**ADDENDUM NO. 2**  
**PHILLIP C. SHOWELL ELEMENTARY SCHOOL**  
**CLASSROOM ADDITION**  
Selbyville, Delaware 19975

May 4, 2015

The documents for the above referenced project, Project Manual, dated March 2, 2015 and Drawings, dated March 25, 2015, as well as subsequently issued addenda, are amended as follows:

LIGHTING FLOOR PLAN  
SCALE: 1/8" = 1' - 0"

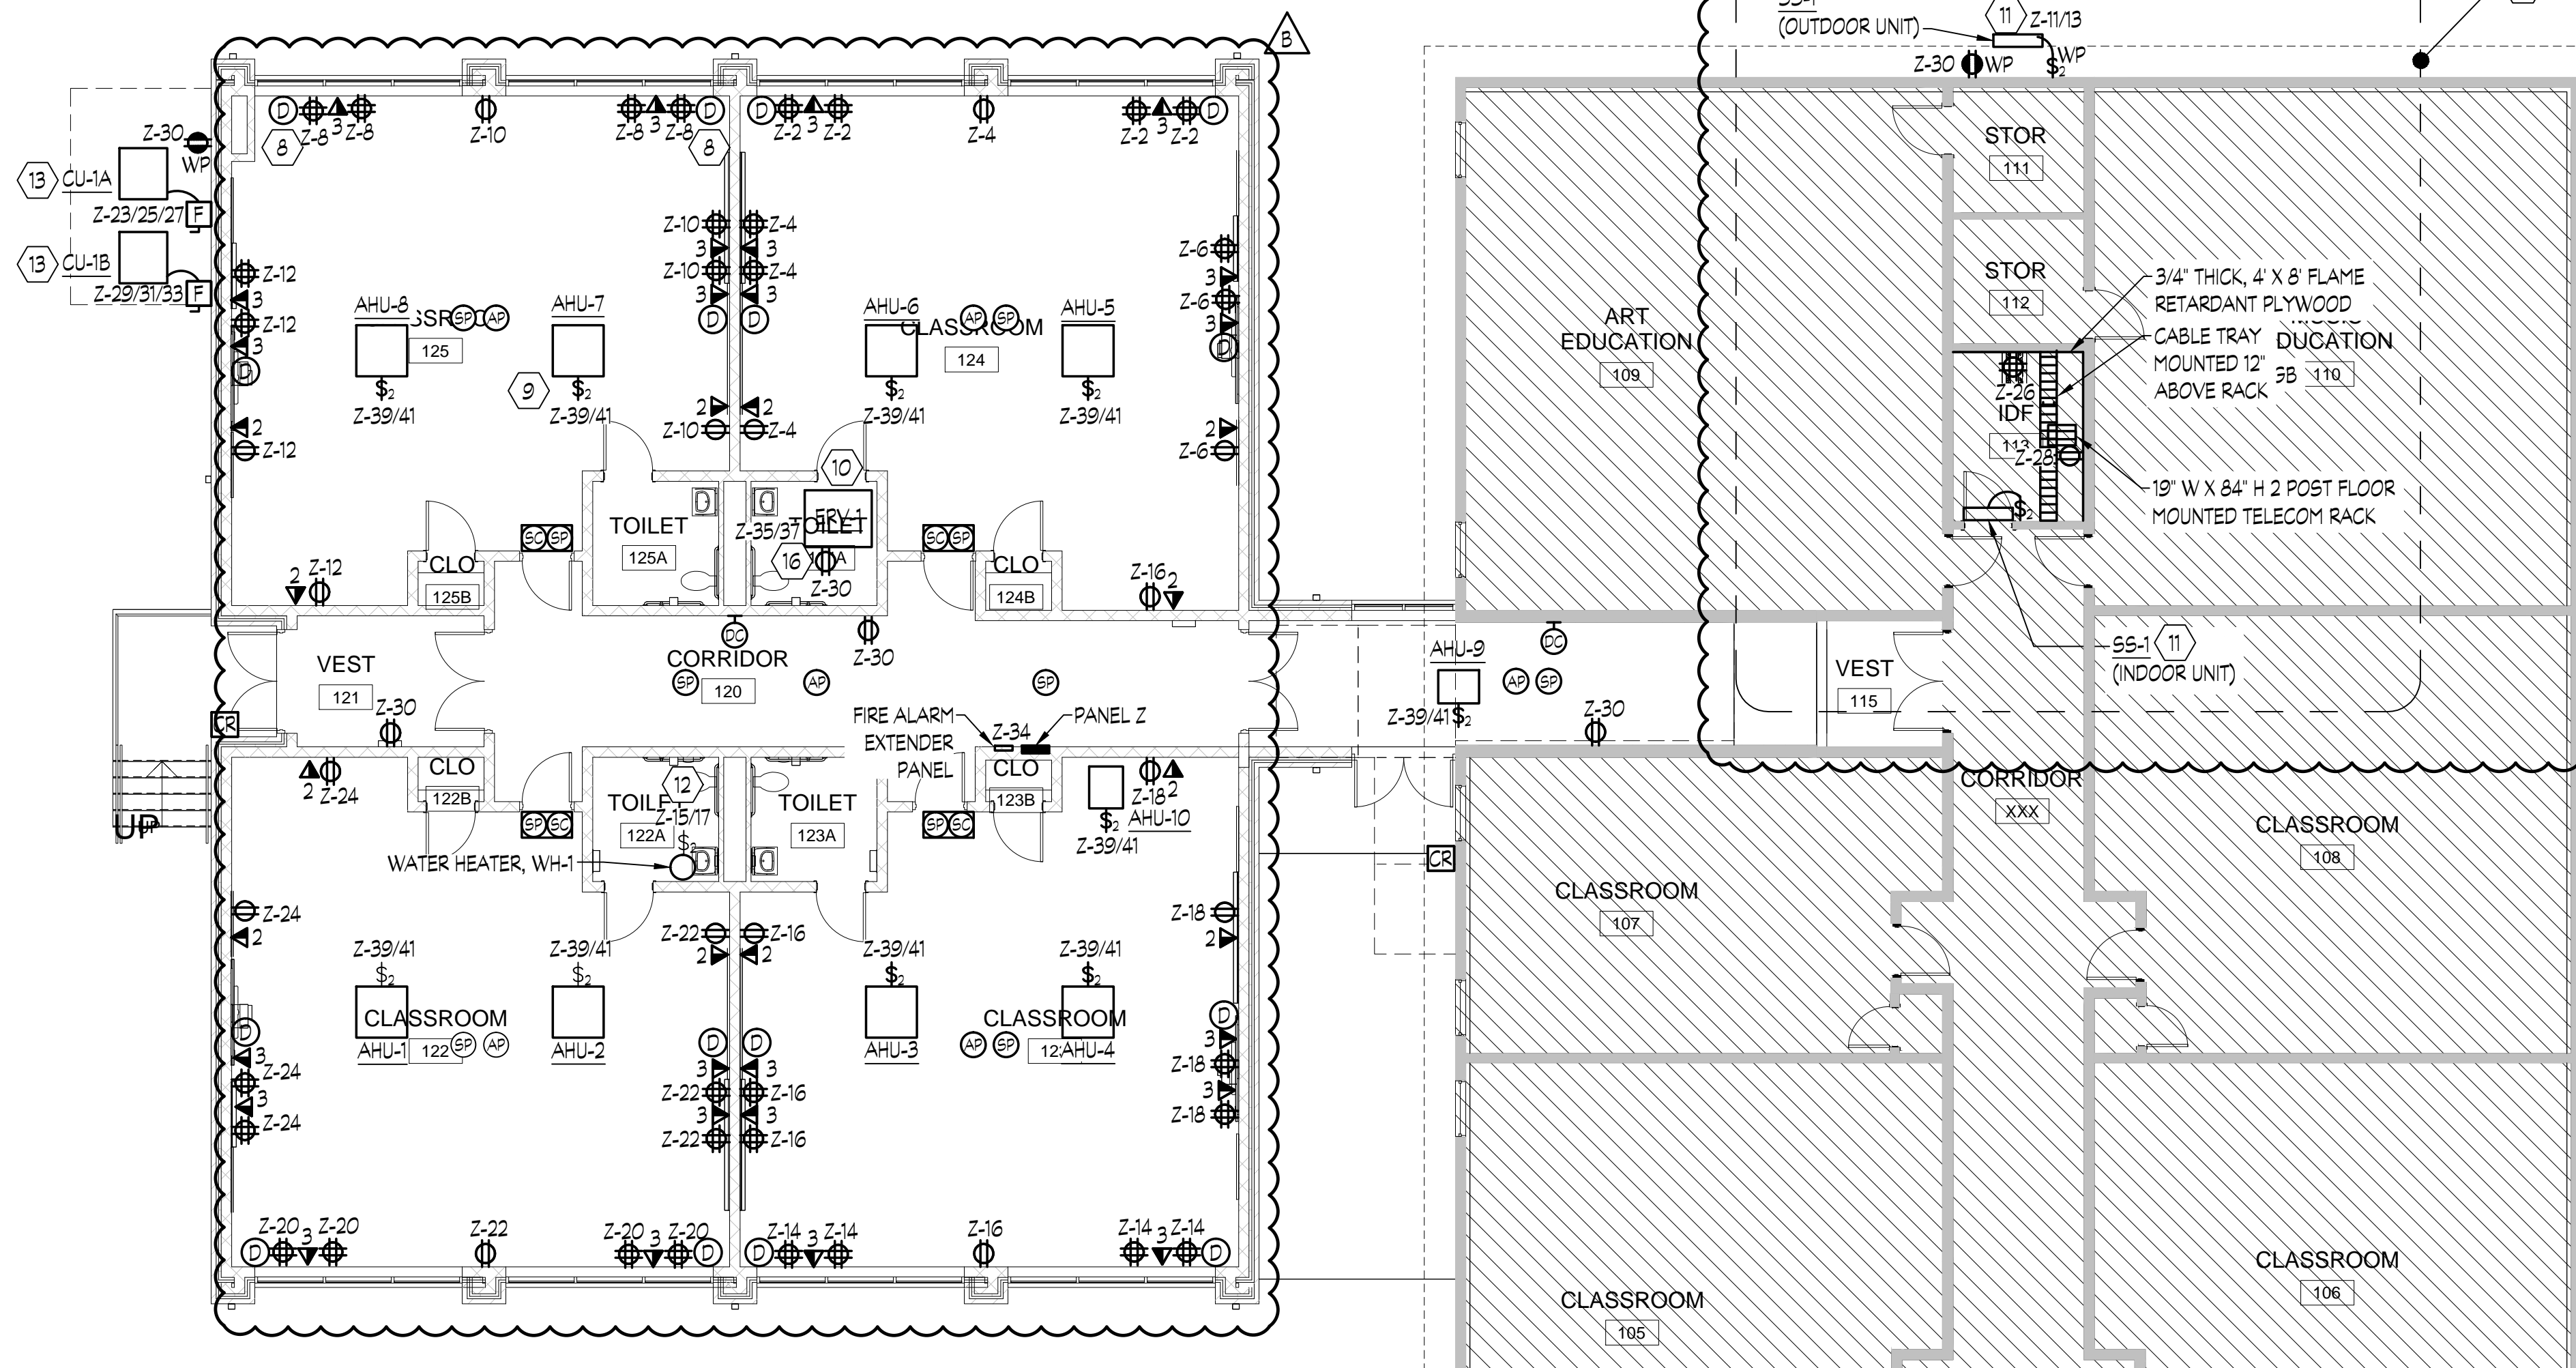
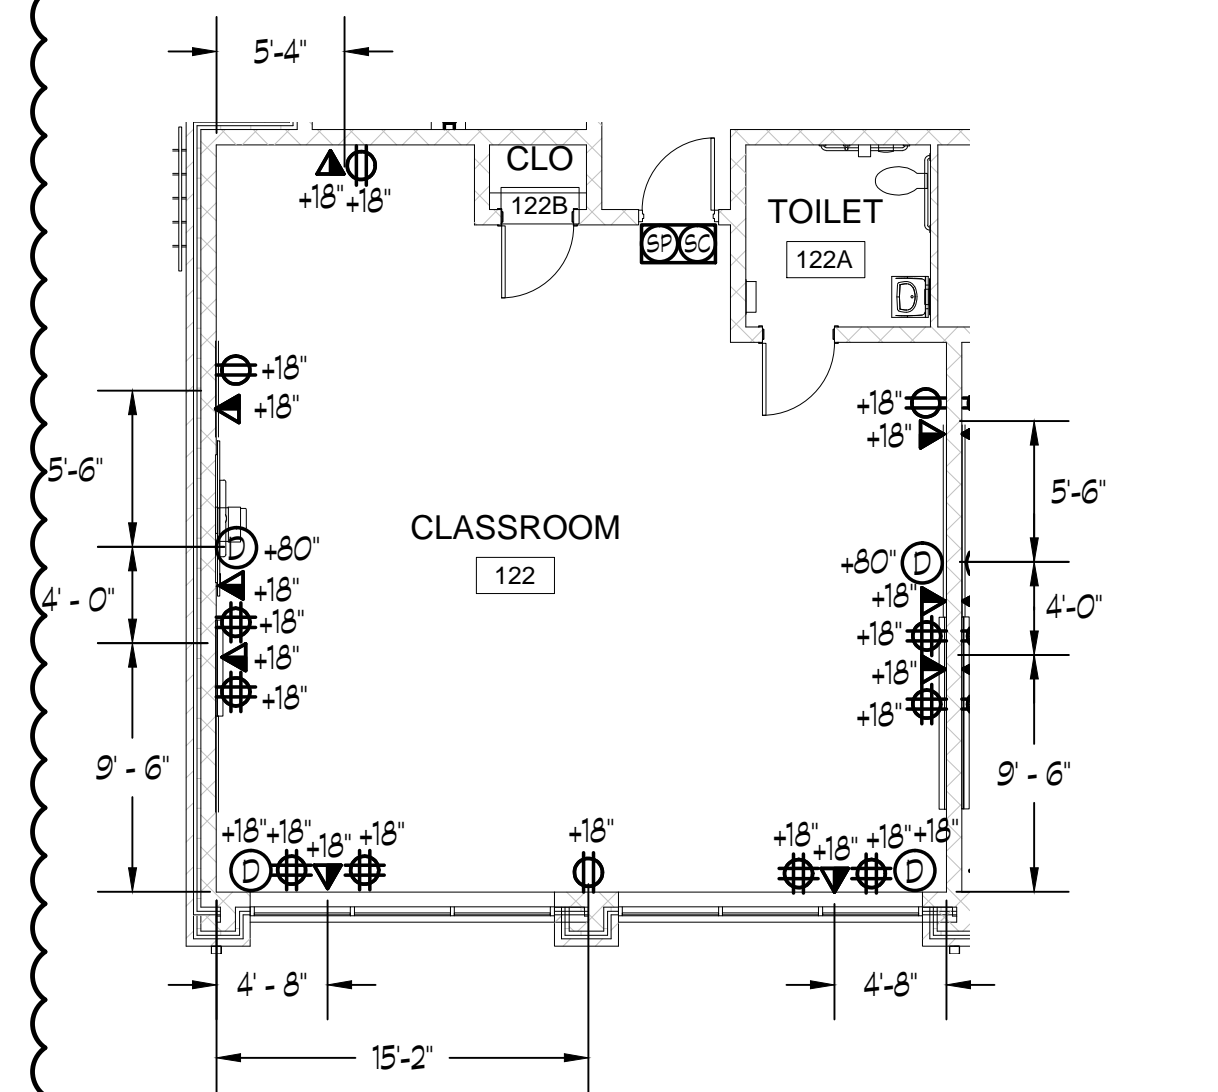
- a. On lighting floor plan, ADD Drawing Note #17 to indicate Type "B" fixture in VEST 121 to be provided with flange kit.
  - b. On power floor plan, ADD Drawing Note #16 to indicate added receptacle to circuit Z-30 at ERV in attic space for maintenance purposes.

- c. On power floor plan, REVISE hall receptacles to indicate circuit no. Z-30 and not Z-7. Circuit was labeled incorrectly.
  - d. On power floor plan, ADD (1) quad receptacle, (2) teacher/smartboard 2" conduit drops, (3) 2 port data drops, and (2) 3 port data drops to each classroom. REVISE spacing/dimensions of device locations.

- e. On power floor plan, ADD Drawing Note #15 to indicate Base Bid and Alternate No. 4 requirements for IDF Room 113.
16. E101:
- a. On fire alarm floor plan, ADD (1) smoke detector to each classroom.

16. MAINTENANCE RECEPTACLE MOUNTED ADJACENT TO ERV IN ACCESSIBLE CEILING SPACE.
17. PROVIDE TYPE "B" FIXTURE AT THIS LOCATION WITH FLANGE KIT.
